**DEFENSE NUCLEAR FACILITIES
SAFETY BOARD**

**DEFICIENCIES IN DOE STANDARD 5506-2007,
*Preparation of Safety Basis Documents for Transuranic
(TRU) Waste Facilities***

**Defense Nuclear Facilities Safety Board
Technical Report**

February 2018

Figure 1. Results of Monte-Carlo statistical sampling test of the MAR algorithm for the case of a uniform MAR distribution, using inventory sizes of $N = 100$ and $N = 1000$.

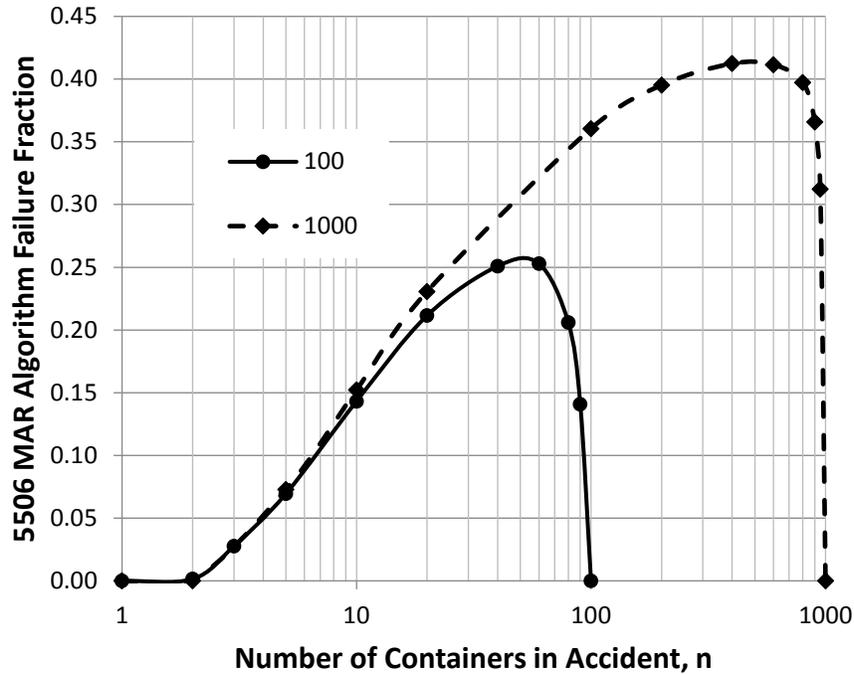
Statistical Tests—To explore the degree of conservatism of the statistical MAR methodology for practical cases of interest ($1 < n < N$), the Board’s staff performed Monte-Carlo statistical sampling tests of the algorithm for well-characterized waste containers. The Monte-Carlo statistical sampling tests involved assuming a MAR inventory of N containers, with some random distribution of MAR among the containers. Given an assumed distribution, the staff computed the *max*, 95th percentile, and *mean*. The staff then took random samples of n out of N containers. The staff computed the actual MAR for the sample and the MAR from the algorithm. Consistent with the Monte-Carlo approach, the staff repeated the sampling process many times. The staff computed the MAR algorithm failure fraction (fraction of cases where the algorithm does not bound the actual sample) based on the sampling results.

Figure 1 shows the results of the staff’s statistical test for the case of a uniform distribution of MAR within an inventory of waste containers. The staff considered two inventory sizes, $N = 100$ and $N = 1000$. The staff performed approximately 20,000 Monte-Carlo sampling trials to obtain each data point shown. The horizontal axis in Figure 1 shows the number of containers involved in the accident, n . The vertical axis shows the failure fraction of the statistical MAR algorithm. Figure 1 shows that the algorithm does not bound the sampled MAR anywhere in the range $1 < n < N$. Any time the failure fraction (fraction of cases where the algorithm does not bound the actual sample) is greater than zero, it means the algorithm does not bound the actual sample for a percentage of tests in the Monte-Carlo statistical sampling tests. The failure fraction exceeds 15 percent for a sample size of 11 to 89 drums out of a given inventory of 100 containers. The failure fraction exceeds 40 percent for a sample size of approximately 200 to 800 drums out of a given inventory of 1000 containers. The Board’s staff also evaluated other distributions of MAR inventories, including Gaussian, lognormal, and skewed, and obtained similar results.

- The Board's staff determined that the statistical MAR methodology outlined in DOE Standard 5506-2007 is not bounding, and is therefore not consistent with DOE Standard 3009-2014, which requires a bounding MAR to be used in hazard and accident analysis. Statistical tests performed by the Board's staff suggest that the statistical MAR methodology may have a high fraction of cases where it fails to bound actual MAR values.

Figure 2. Variation of the mean MAR among rooms at WIPP.

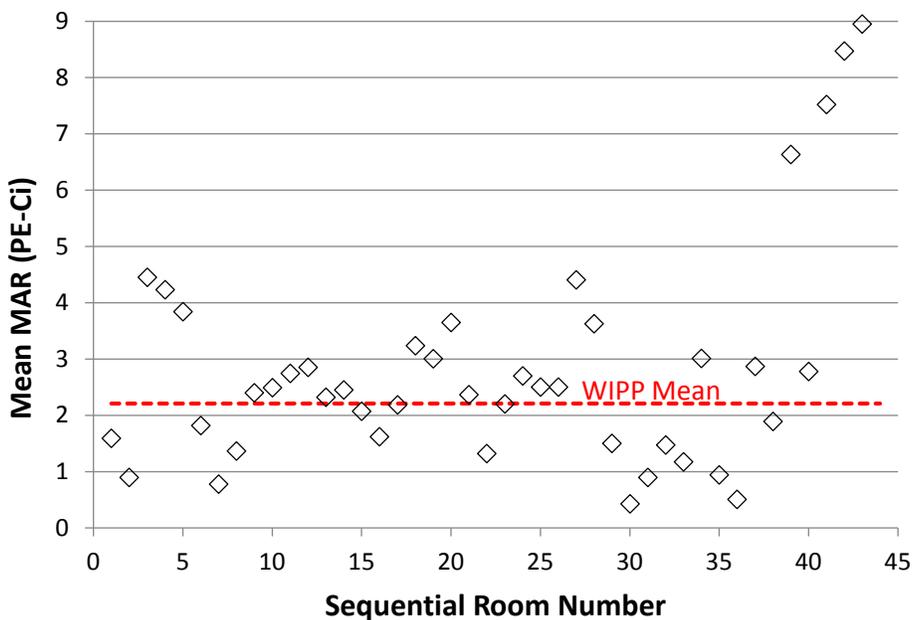
Evaluation of WIPP Inventory—The Board’s staff evaluated how the quantity of MAR in emplaced 55-gallon drums varies within the underground at WIPP. The staff calculated the mean MAR in 55-gallon drums for each of the 43 rooms in the WIPP underground. Figure 2 shows the calculated mean MAR in 55-gallon drums by room number. The dashed line shown in Figure 2 is the mean MAR for all 55-gallon drums at WIPP, 2.21 plutonium equivalent curies (PE-Ci). WIPP uses the mean MAR for all 55-gallon drums underground at WIPP when applying the statistical MAR methodology. However, Figure 2 shows that the mean MAR per room varies considerably in the WIPP underground. The Board’s staff concluded the variability in MAR per room is not random statistical variation, since the rooms contain a large number of drums (approximately 2,000 per room on average). The results shown in Figure 2 suggest that bias associated with individual waste transfer campaigns from different sources contributed to the variation. The staff’s conclusion calls into question the conservatism of the statistical MAR methodology, which relies on the global mean MAR to compute the MAR involved in a localized accident.

- The staff's analysis of MAR in the WIPP underground demonstrates that relying on global waste inventory for formulation of key inputs to the statistical MAR algorithm in DOE Standard 5506-2007 may not be appropriate.

Figure 3. DOE Standard 5506-2007 interpretation of aircraft and vehicle crash assumptions.

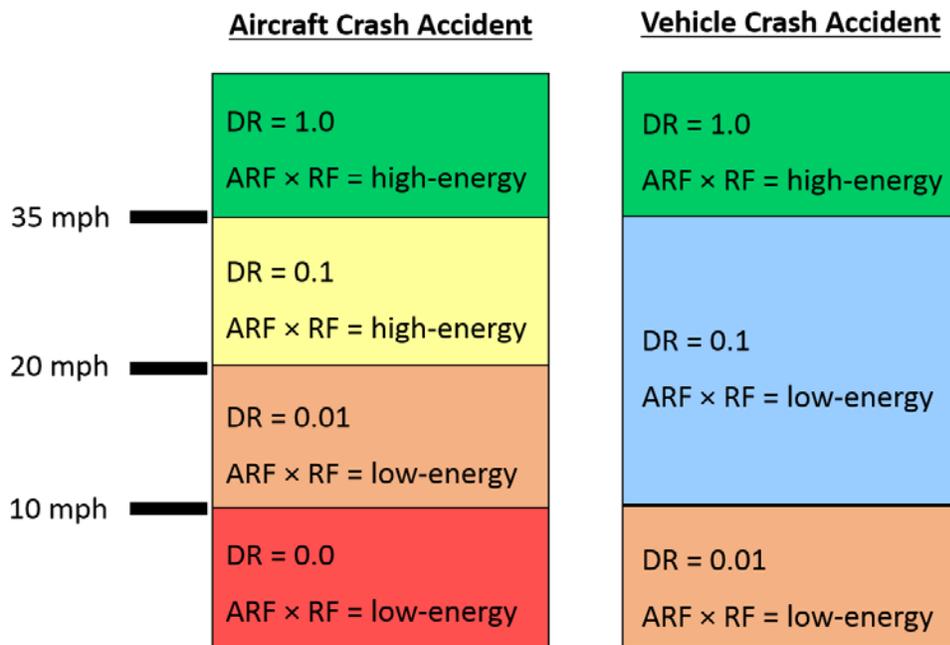
The guidance in DOE Standard 5506-2007 for estimating a radioactive material release due to a vehicle crash or aircraft crash into TRU waste containers does not provide sufficient detail to ensure consistent and conservative application across all TRU waste facilities. Furthermore, the lack of detail has contributed to inconsistent application of damage ratio and airborne release fraction times respirable fraction (ARF×RF) values for vehicle and aircraft crashes. Figure 3 illustrates how aircraft and vehicle crash accidents have applied different combinations of damage ratio and ARF×RF as a function of impact velocity, based on interpretation of guidance provided in DOE Standard 5506-2007.

Low-Energy vs High-Energy vs Catastrophic Impacts—The ARF×RF values cited in DOE Standard 5506-2007 can differ by an order of magnitude, based on whether they are classified as low-energy or high-energy impacts. DOE Standard 5506-2007 states that the high-energy impact ARF×RF values are applicable to a container fall from the fifth tier of stacked drums. This equates to a fall height of approximately 13.7 feet. A 13.7-foot fall height results in an impact velocity of approximately 20 miles per hour. A commonly used method in the aircraft crash accident analysis is to use the impact velocity calculated for a 13.7-foot fall height (i.e., 20 miles per hour) as the threshold above which high-energy impact ARF×RF values are applied.

When evaluating ground vehicle crash accidents, the high-energy impact ARF×RF values are generally not applied unless vehicle speeds are expected to be greater than 35 miles per hour, which is inconsistent with the 20 miles per hour threshold commonly used in aircraft crash

DOE Standard 5506-2007 should clearly provide the thresholds that determine which damage ratio and ARF×RF should apply to both the aircraft and vehicle crash accidents, such that application is consistent for all relevant accident scenarios. Multiple variables must be
